ADDENDUM NO. 1

**BUSINESS 50 WEST IMPROVEMENTS
PROJECT NO. 2018-301-0**

**COLE COUNTY DEPARTMENT OF PUBLIC WORKS
March 10, 2021**

SHEET 8

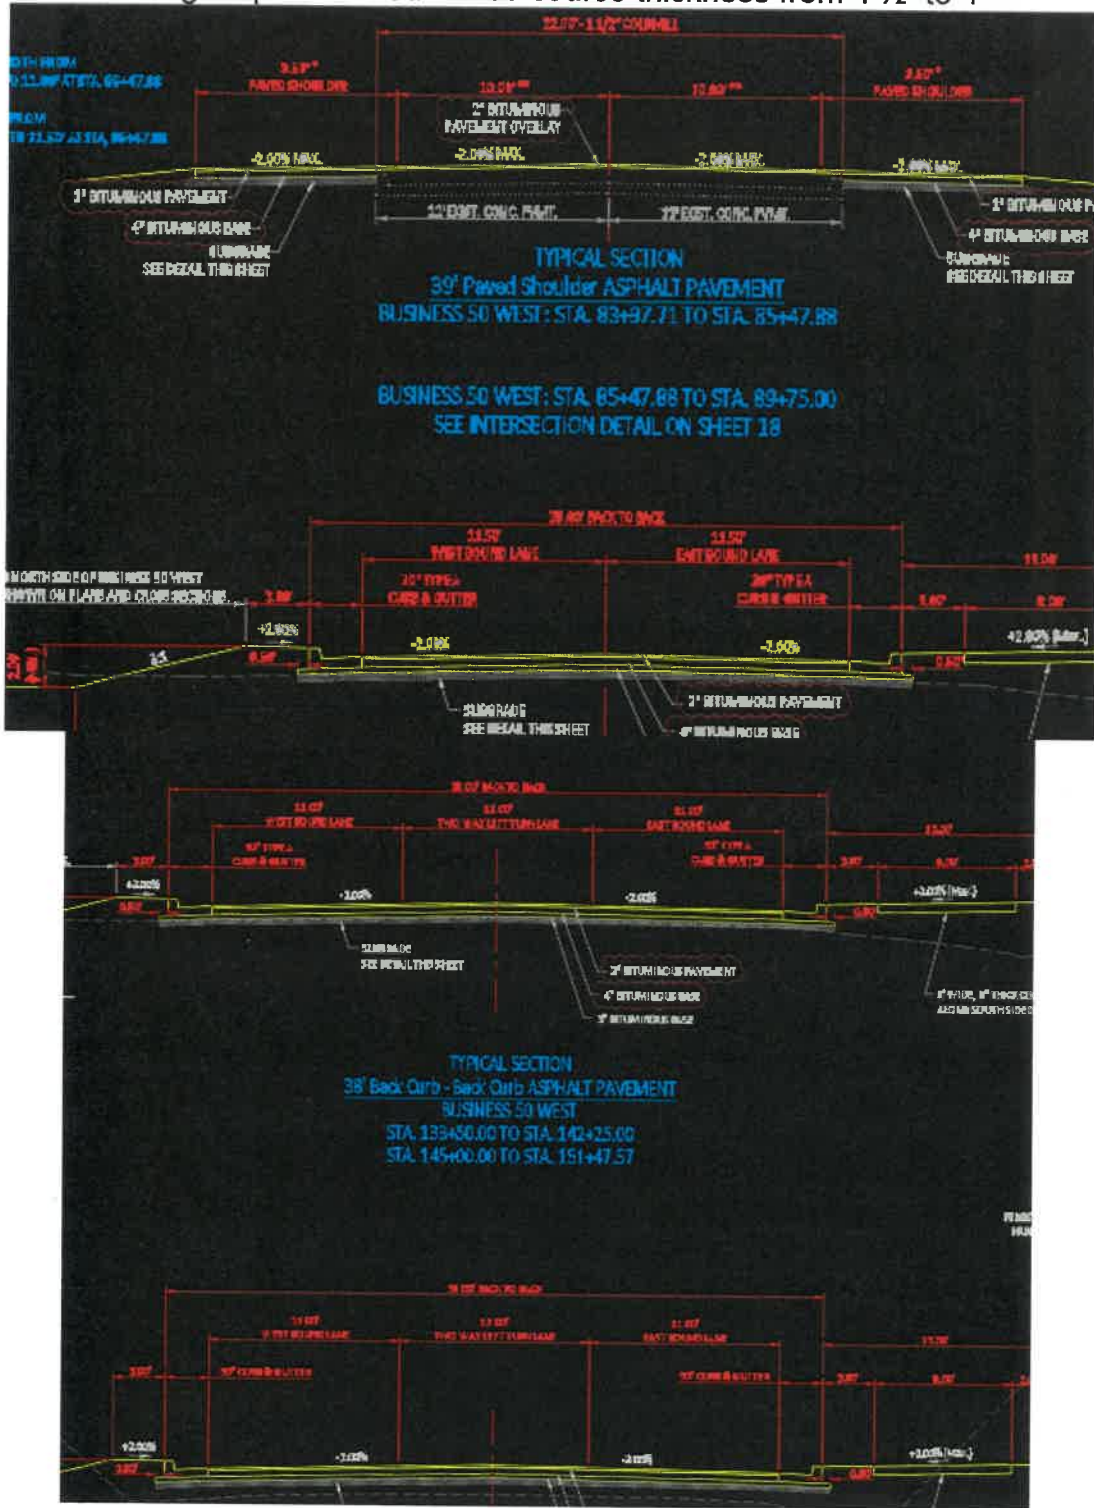
- Change Bituminous Pavement thickness from 1 ½" to 2"
- Change top Bituminous Base course thickness from 4 ½" to 4"
